BROCKWAY
ENGINEERING
P.L.L.C.

Re: Fish Creek Reservoir Company – Aquifer Recharge Plan
Project No. 052-05-2005

PERCENTAGE OF RECHARGED VOLUME RETURNING TO THE SNAKE RIVER FROM FISH CREEK RECHARGE SITE

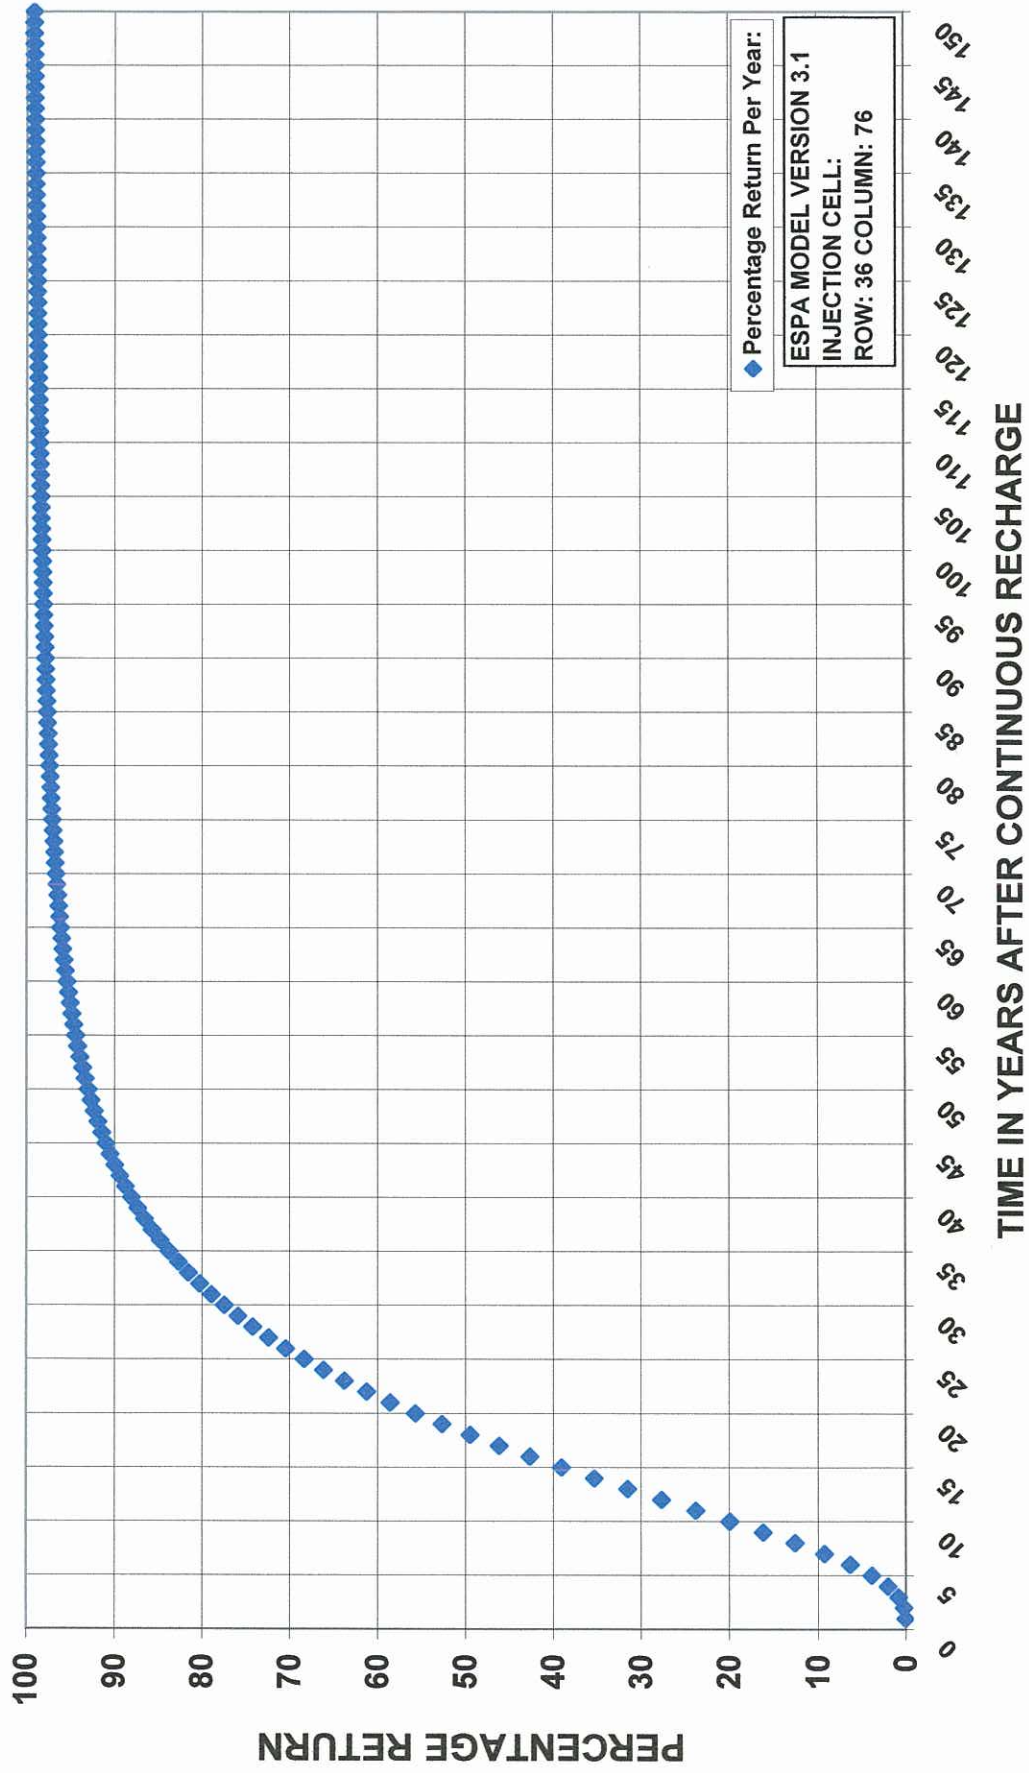
The attached plots show the predicted increase in Snake River reach gain in terms of percent of water recharged. The “new model” was used to make these runs, with a 1,000 ac-ft recharge occurring every year in the spring

trimester (April – June). Due to the proximity of the recharge, short-term benefits will likely be small except near the recharge area. For example, after 10 years only 20% of the total increase in Snake River reach gain is predicted to be realized. However, the value as long-term mitigation could be significant, depending on the location of the water usage to be mitigated. The model predicts, at steady state, that 69% of the total benefit will occur in three reaches: 39% in Near Blackfoot to Neeley, 18% in Devils Washbowl to Buhl, and 12% in Shelley to Near Blackfoot. The benefit to all other reaches is less than 10%. These results indicate that the recharge may be useful in mitigating for groundwater pumping depletions affecting the natural flow water supply for the Surface Water Coalition members and the spring outflows at Blue Lakes Spring, Crystal Springs, and others in the vicinity.
